MINNEAPOLIS	HONEYWELL REG	Oved For Release	asæ 866	12462483 NGIAC	RARG 2 BO		CONTRACTOR S RECOMMENDED PRIORITY	
AERONA	ON	PROPOSAL ADM-956 REV. 8/60 EMERGENCY WUPGENT ROUTIN FOR USE WITH ANA BULLETIN NO. 391						
1 ECP NO.		DATE	CONTRA	CT NO.	APTICLE 1	IN PRODUCT	ION	
1		7-12-63		4004	x	YES	NO NO	
2 NAME OF CO	MPLETE ARTICL	E		MODEL, TYPE DE		, SPEC, DW	G. NO.	
Navigati	on P anel			CG8006	6A1			
3 NAME OF PA Switch H		SUBASSEMBLY AFFE	CTED				PART NO.& MODEL. OR TYPE NO. OF PAR OR LOWEST SUBASSEMBLY AFFECTED AD907599-2	
4 NATURE OF	CHANGE					GFE AFFE		
		on Select Swi functions.			ont	YE	X	
							. AT CONTRACTOR'S PLANT CHECK ONE)	
5 REASON FOR		UDE EXPLANATION	OF ITEMS	CHECKED IN NO.	BELOW OR			
Increase capability of selecting destinations from 8 to							X REQUESTED BY PROCURING ACTIVITY IN	
16 locati	ons. See.	Attachment				<u> </u>		
						. [SPEC.NO.

ENGINEERING CHANGE PROPOSAL

E.C.P. NO. 1

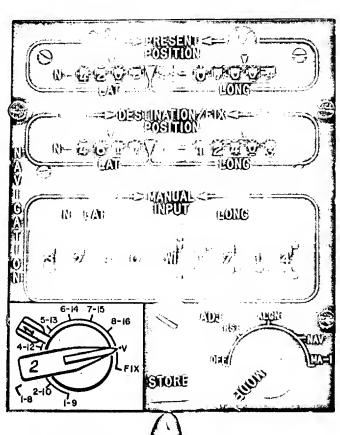
This modification will require the replacement of the present destination select rotary switch on the Nav Panel with a concentric shaft rotary switch. This switch will contain an inner shaft with four decks and ten positions (switch #2) as is currently used, and the outer shaft with a single deck and two positions (switch #1). Switch #1 is a lever type switch.

In operation switch #2 will transmit four lines of binary information which will be decoded by the computer for the purpose of selecting one of eight possible destinations. Prior to this selection, the computer program will look at the output of switch #1. This is in the form of a discrete to the computer. If the contacts of switch #1 are open, the decoded output of switch #2 will be recognized as destinations 1 through 8. If the contacts of switch #2 are closed, the computer will recognize the output as destinations 9 through 16.

The present face plate will require a replacement with one containing the engraving necessary to display the additional destinations. In addition, a minor redesign of the panel lighting technique will be required.
